MEMORANDUM

TO FILE: American Nuclear Corp., Permit 357
 FROM: Jim Finley, Hydrologist
 DATE: October 29, 1985
 SUBJECT: Review of Groundwater Conditions and
 at the American Nuclear Mill Site

Figure 1

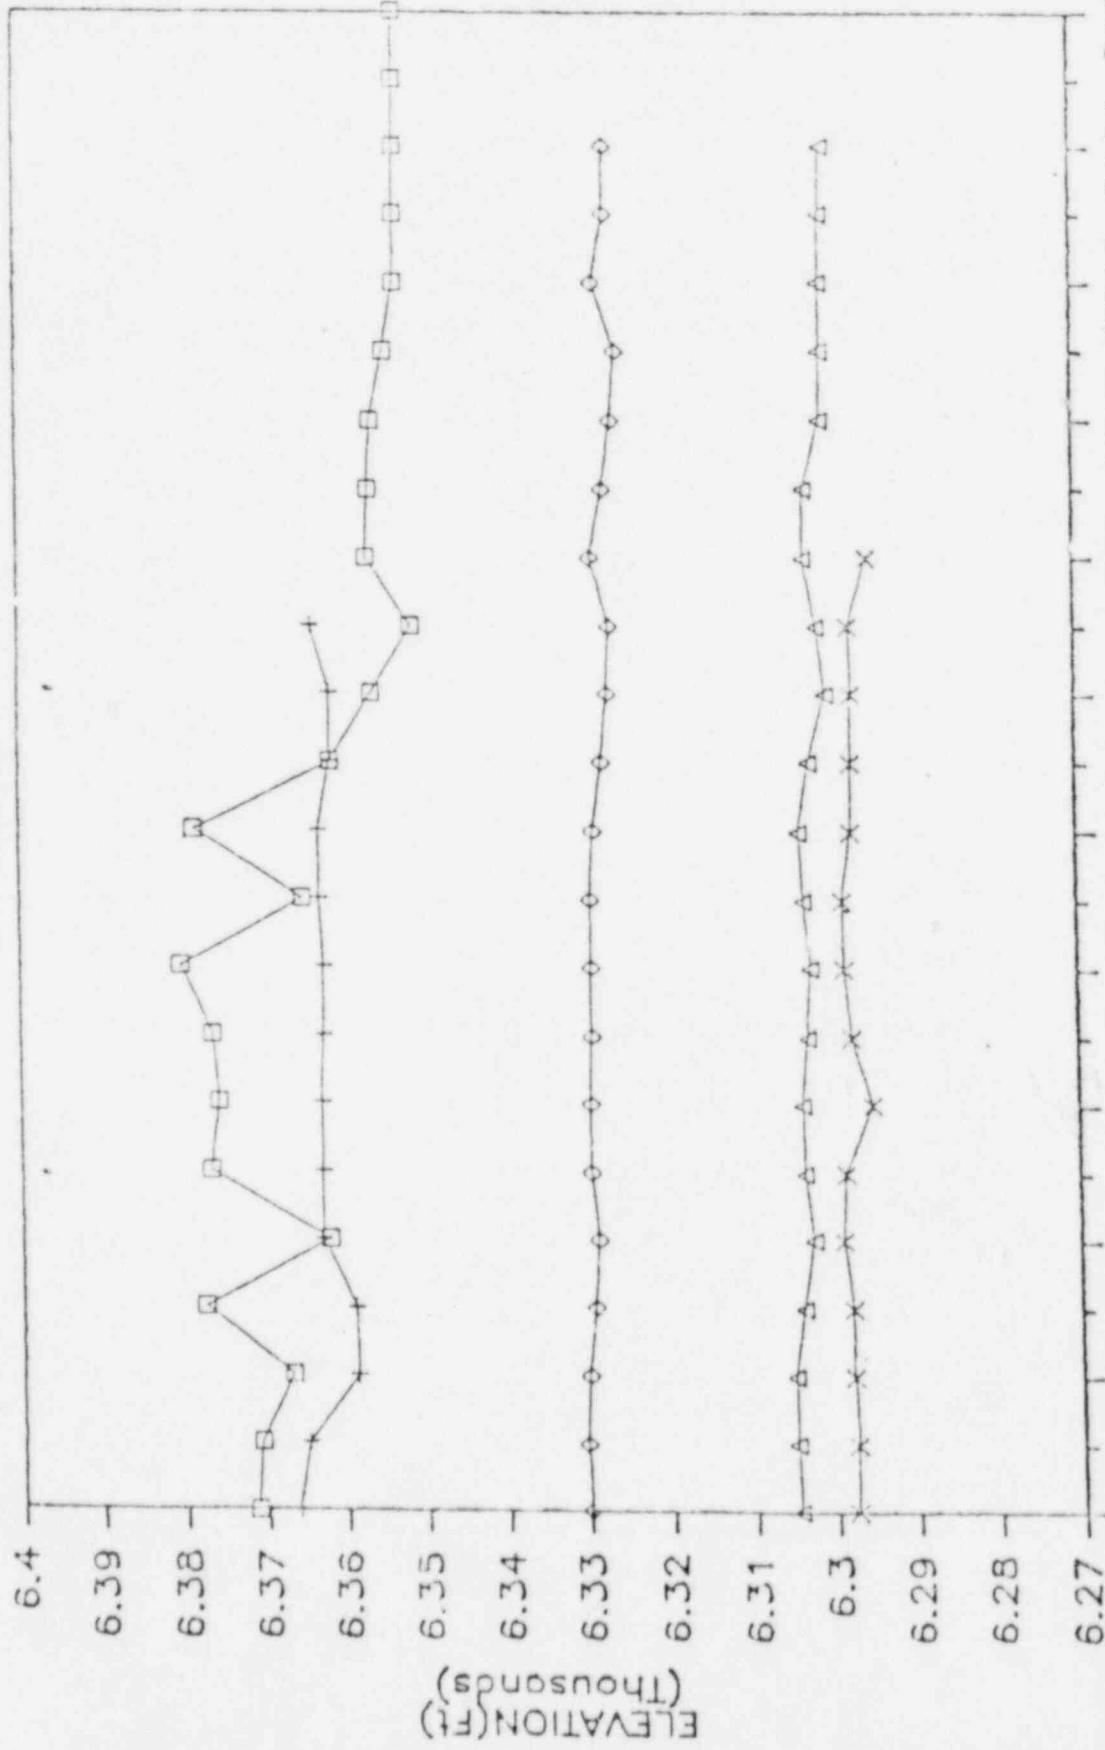
A new review of the data contained in the report was conducted in which both water levels and water quality were analyzed. Water levels for several monitoring wells were plotted against time. Water levels from five wells indicate that the pumpback system has not historically had much of an affect on the flow gradient (Figure 1). With no baseline or pre-1979 data, it is not possible to determine whether or not these down gradient water levels reflect the influence of seepage. Some of the original mathematical modeling of the perched aquifer indicates that water from this aquifer discharges approximately 2000 feet north of the tailings pond. The piezometric map and Figure 1 suggest this is not true, but that a discharge area possibly exists to the north of the Fox wells. Water levels are below the topographic surface in the three Fox wells plotted on Figure 1.

Figure 2

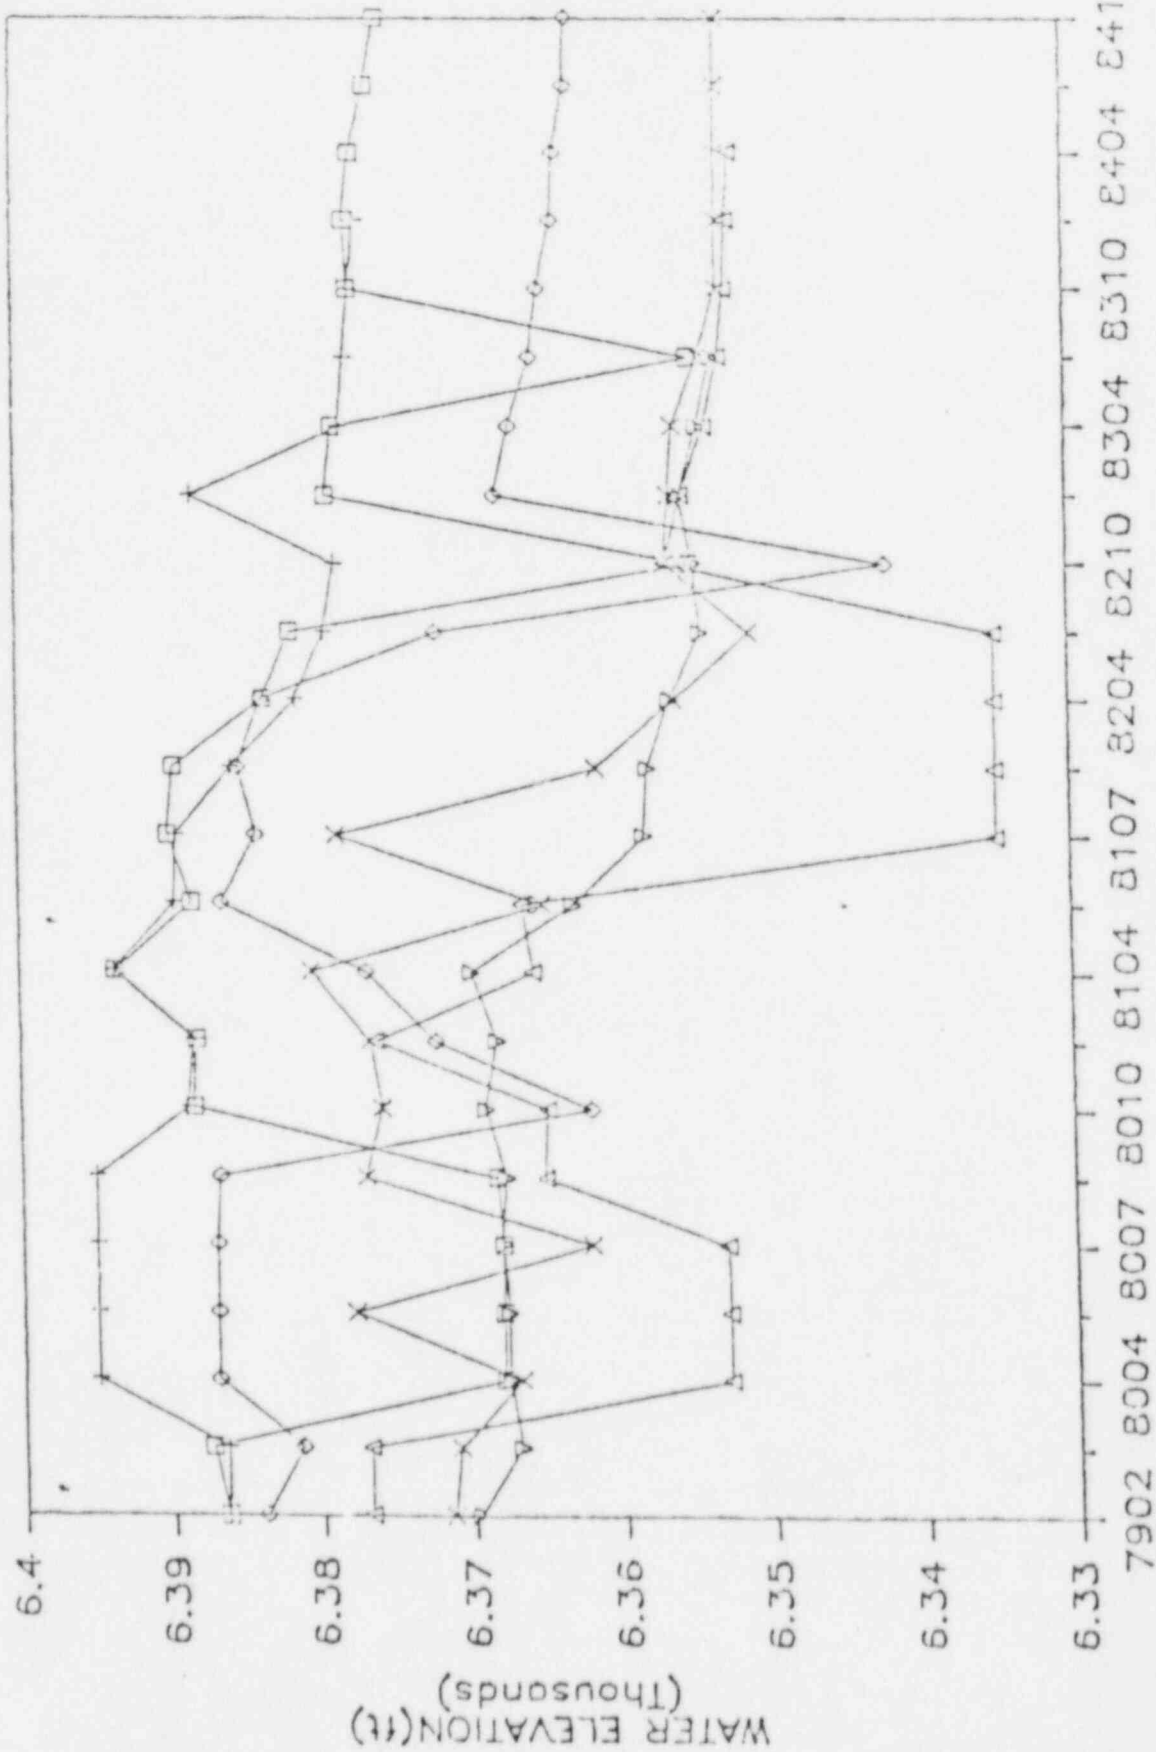
Periods of active pumping from the recovery wells have been sporadic for all wells (Figure 2). Water levels in the recovery wells have decreased since 1979, which is a combination of pumping and decreased water levels in Tailings Pond 1. R-4 has been pumped the most actively though water remains in all wells but R-5. This is not surprising considering that these wells should be drilled to the top of the clay and pre-mining water levels existed in the perched aquifer. Through time, decreased water levels in these wells should become stable, at which point seepage from the tailings pond will have ceased.

An effective pumpback system is necessary in order to minimize further seepage movement into the perched aquifer. The well system has not worked very reliably to date (Figure 2; see August 6, 1985 memo Niles Andrus to NRC). A rejuvenation of the well system coupled with a more effective evaporative technique (e.g. a mist system) should be considered for any decommissioning of this tailings pond.

Figure 3

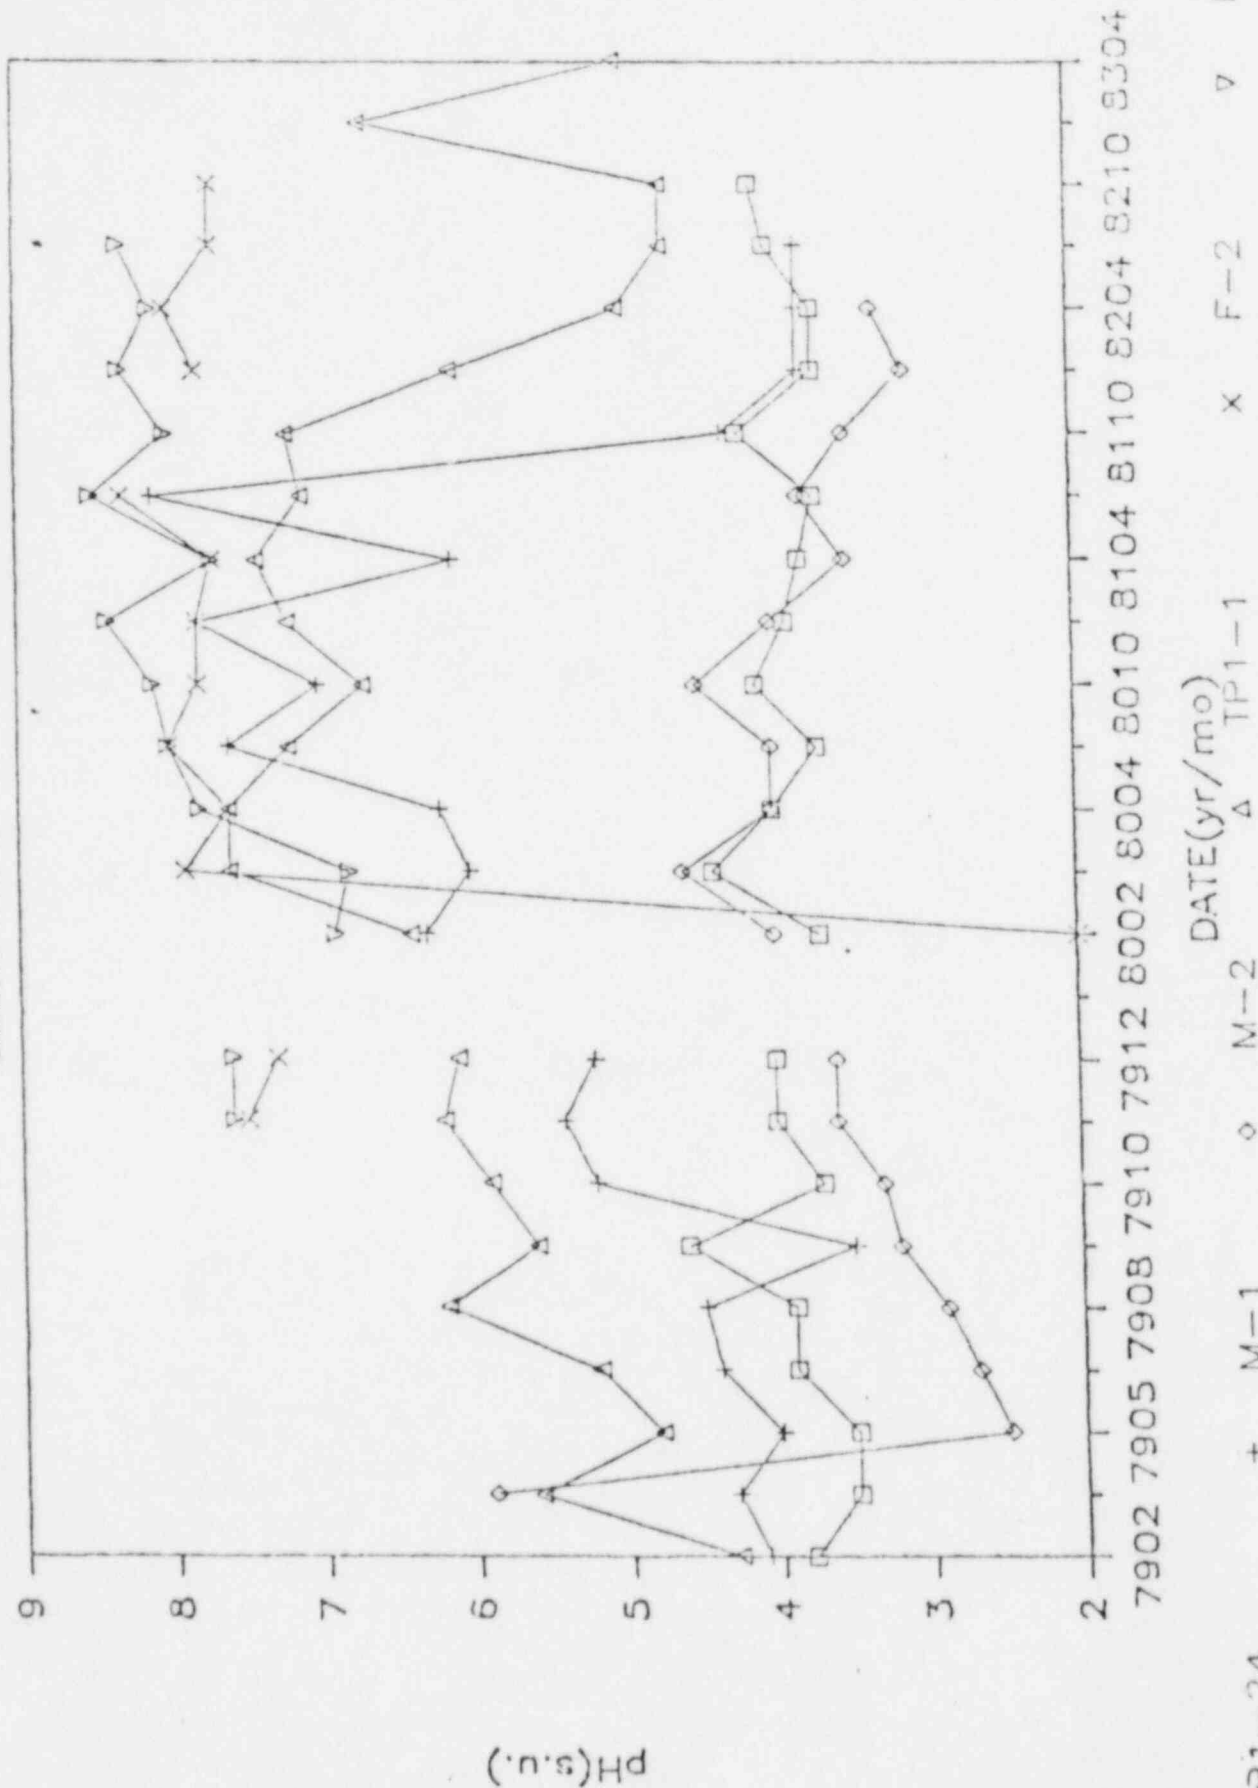
Several water quality parameters were plotted against time for wells in a down gradient direction (Figures 3, 4, 5, and 6). Values of pH rise from two (tailings liquor) to eight as distance down gradient of the tailings is increased (Figure 3). Low pH fluids seeping from the tailings pond are buffered by the natural salt content of the perched aquifer. The rate at which the buffering occurs is controlled by two processes: (1) reaction kinetics; (2) and relative permeability of the aquifer. Reaction kinetics is fixed if the medium is homogeneous. Directional permeability will control rates of flow affecting contact time. Zones of increased permeability (e.g. sand or gravel lenses) will transport low pH water further from the tailings pond. Changes in pH and Eh regulate the relative solubility of major cations and anions, and indirectly the chemistry of toxic trace elements (Johnson, 1985). Values of pH below 6 occur as far down gradient as TP1-1 (Figure 3). It is expected that the zone of low pH will slowly increase in size as the buffering capacity of the aquifer material is exhausted.

Figure 4

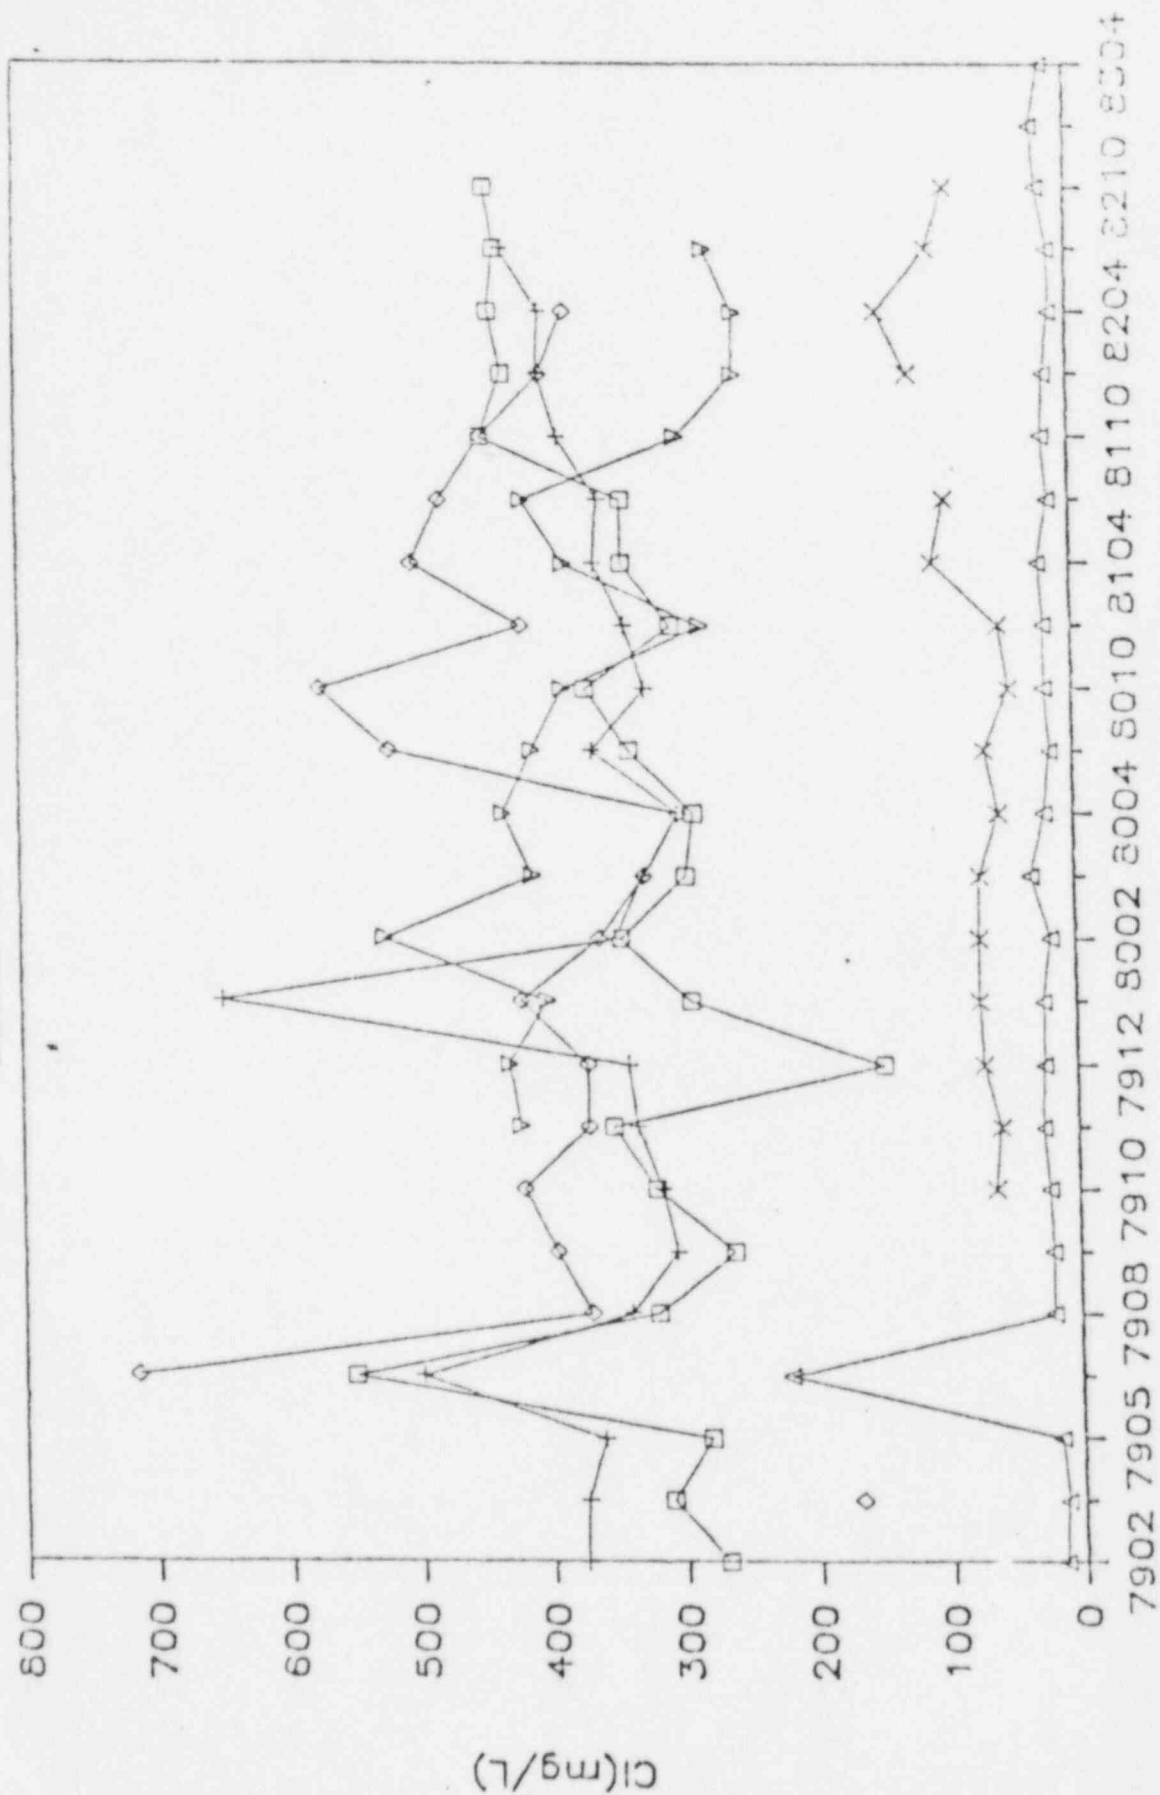
Chloride concentrations show no increasing or decreasing trend for any wells through time (Figure 4). Values range between 250 and 575 mg/L for all wells but Fox 2 and TP1-1. This again suggests that the sampling conducted to date reflects not pre-seepage conditions but those already created as a result of seepage. Other constituents plotted reflect the same conditions (Figures 4, 5, and 6). Nitrates at three wells peak in late 1981 then drop to within 10 and 20 mg/L (Figure 5). Sulfates generally increase in a down gradient direction with very high values recorded at Fox 5. Four wells range between 2000 and 7000 mg/L with a rising trend from 1981 to late 1982 (Figure 6). In all cases, Well TP1-1 had the lowest concentration of all parameters which indicates the plume has not moved in this direction. Flow may move in a more westerly direction though data are not available to evaluate this possibility.
